Council Reference: A006632675

RE: Request to make a 'Minor Change' under Section 81 of the Planning Act 2016 to a Development Approval – Material Change of Use for a Multiple Dwelling (5 Units) in the Traditional Building Character Overlay at 12 Abbott Street, New Farm

Since approval, the project has progressed to detailed design. As part of this design process, specialist fire engineering feedback and design development has led to changes to the approved development. The applicant now seeks to regularise the changes by requesting a 'Minor Change' to the approval pursuant to Section 81 of the Planning Act 2016 ("The Act"). The changed proposal complies with the relevant assessment benchmarks having regard to the existing approval. We therefore request the approved plans and conditions are altered in accordance with Section 83 of the Act.

Figure 3: Proposed Plant screening and bathroom location - Extract (Source: ELK Architects)

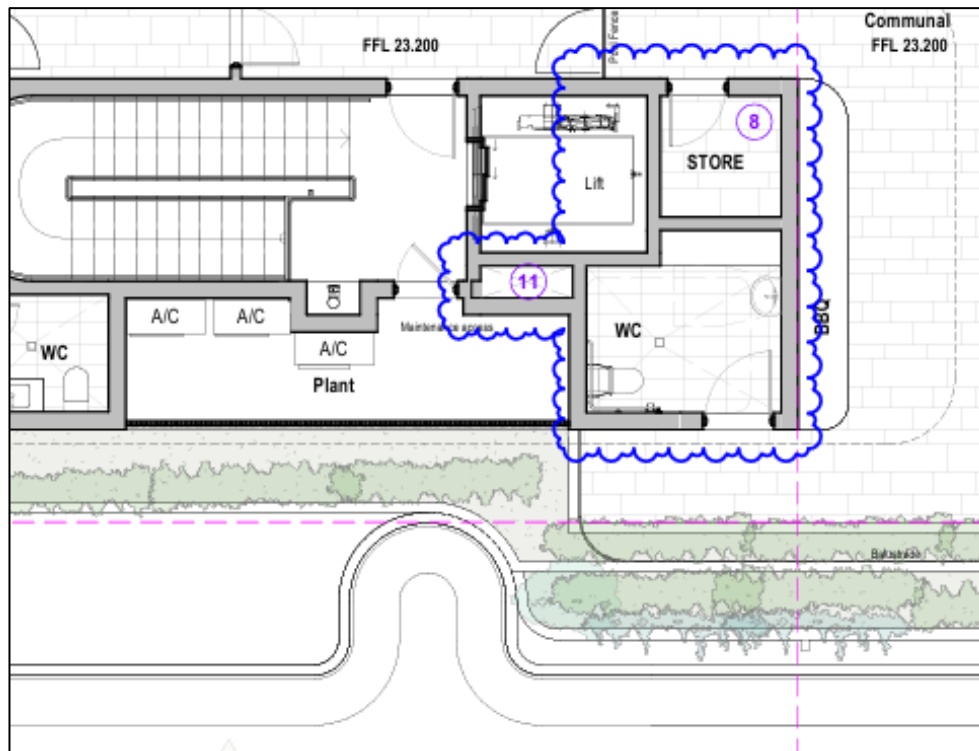
The changes involve a minor alteration to the existing external bathroom located on the roof terrace level. The approved communal bathroom adjoins the plant area located on the roof which houses a number of servicing components. Due to the location and capacity of the mechanical exhaust within this area it is proposed to move the bathroom wall 1500mm (or 864mm beyond the approved building line) to the north, increasing the plant area space to house the exhaust. To keep the plant room similar size as approved, the private bathroom on the roof terrace moved 600mm north, with an overall 900mm increase to the plant room and screen.

The proposed change is considered typical of the detailed design process and ensures the practicality, privacy and amenity of the roof space is maintained.

The proposed changes to the roof involves a minor increase in height of 250mm. The proposed increase to the upper roof height is to accommodate an additional 200-250mm insulation layer required to achieve improved thermal performance, energy efficiency, and long-term building durability within the stair core and amenity spaces. The proposed 250mm increase to the roof height seeks to improve the functionality of the spaces and ensure they appropriately reflect the quality and design of the development in a cohesive manner.

Figure 4: Proposed booster assembly location - Extract (Source: ELK Architects)

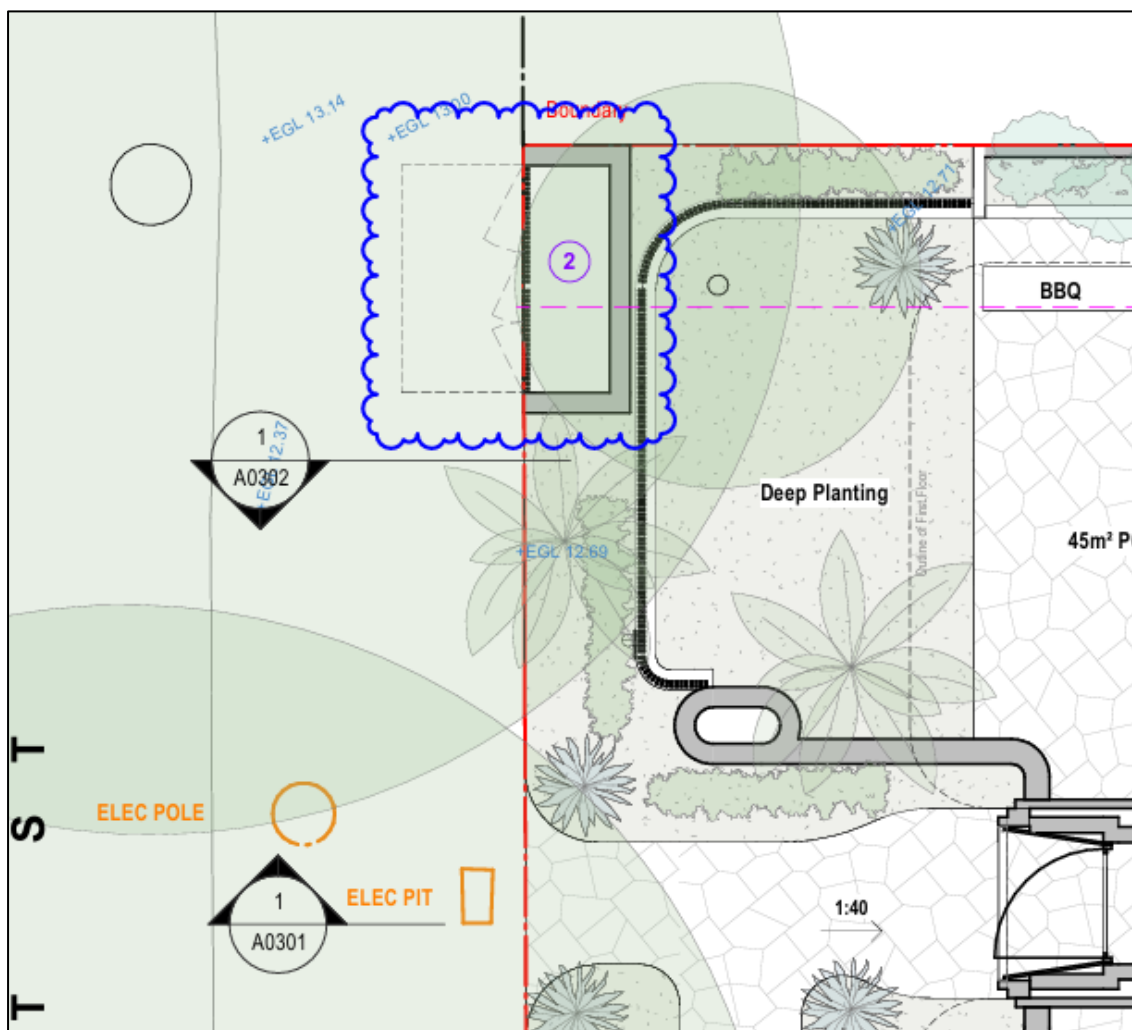
The proposed changes involve an alteration to the location of the fire hydrant booster assembly and pad to ensure requirements with respect to fire safety can be appropriately

met. The existing approval details the booster assembly located to Watson Street, however through detailed design it has become evident all fire servicing for the project need to occur from Abbott St and as such the booster needs to address this frontage.

Figure 5: Proposed fire egress stair location – Basement Extract (Source: ELK Architects)

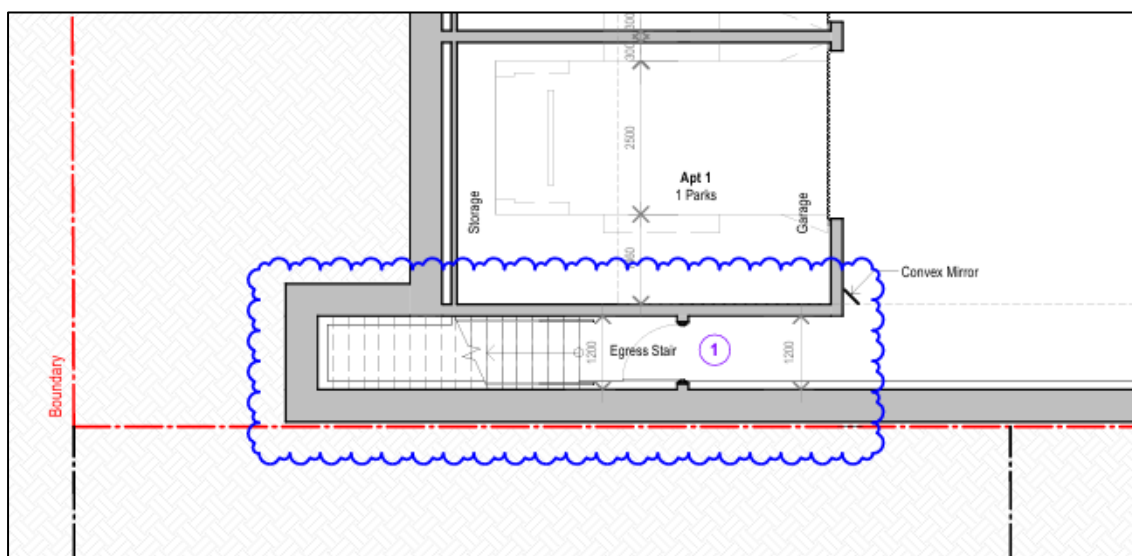
It was previously intended that emergency egress from the basement be from Watson St, however through detailed design and feedback from the fire engineer on the fire brigade access strategy, it has become evident this escape needs to address Abbott St and as such a set of stairs has been added. The proposed fire egress stairs are located in the south-eastern corner of the development. The proposed escape stairs are externally located so to not inhibit the function of the adjacent ground floor unit, whilst ensuring an appropriate outcome with respect to fire safety requirements.

Figure 6: Proposed fire egress stair location – Ground Floor Extract (Source: ELK Architects)

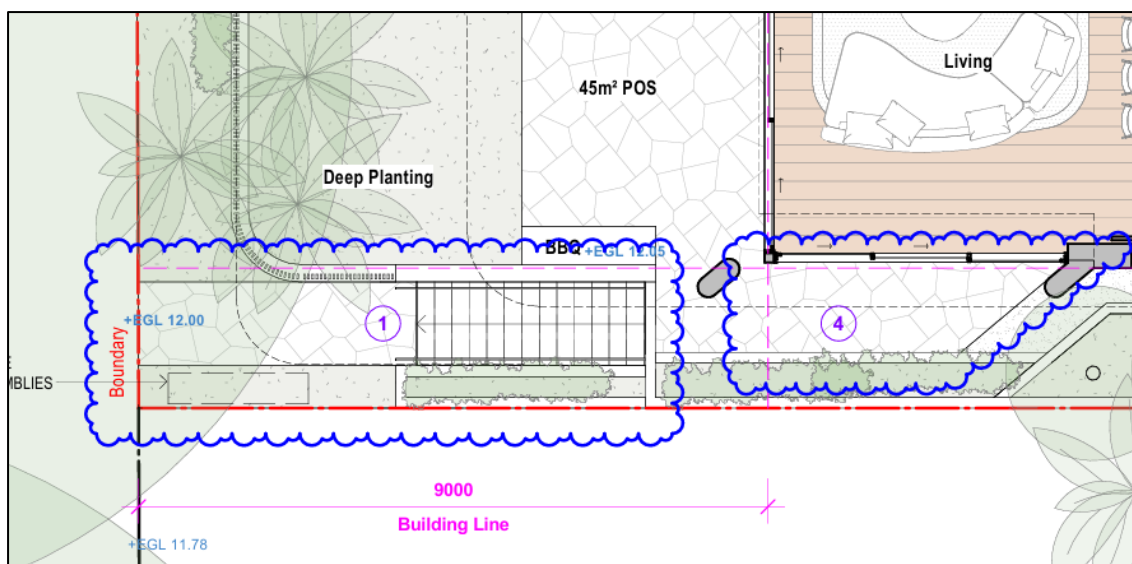
The approved landscape outcome is intended to be maintained, and all works are appropriately separated from the street trees within Abbott St.
